AMENDMENTS TO THE DRAWINGS:

REMARKS

ANNOTATED SHEET SHOWING CHANGES

Fig. 1

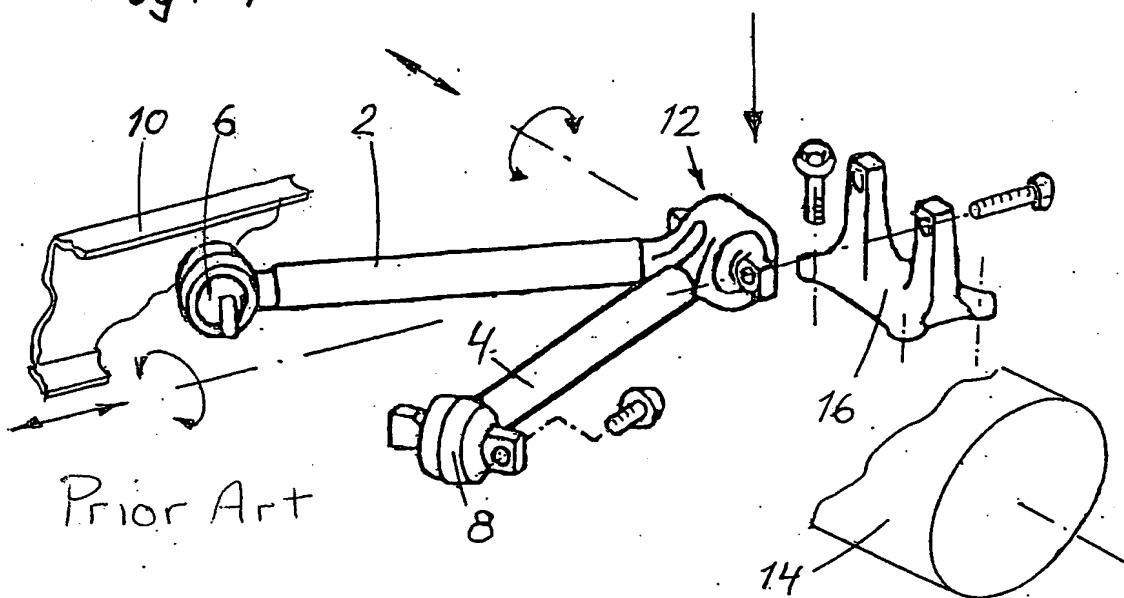
The abstract has been amended as requested. The specification has also been amended to comply with Rule 77 and to correct a typographical error. Enclosed are corrections in red to Figs. 1 and 2 to indicate they relate to the prior art and replacement drawings incorporating these corrections.

In the Office Action the Examiner questioned the recitation in lines 6-7 of claim 1 to “an axially extending outer surface (64)” and to “two substantially radially extending end surfaces (68, 70).” With reference to Fig. 1, it can be seen that surface (64) of rubber-elastic element (60) extends in an axial direction and surfaces (68, 70) thereof in a radial direction with respect to axis (66). Thus the limitations are basically correct. For clarity they have now been amended to recite “an outer surface extending parallel to the axial direction” and “two end surfaces extending substantially radially to the axial direction.”
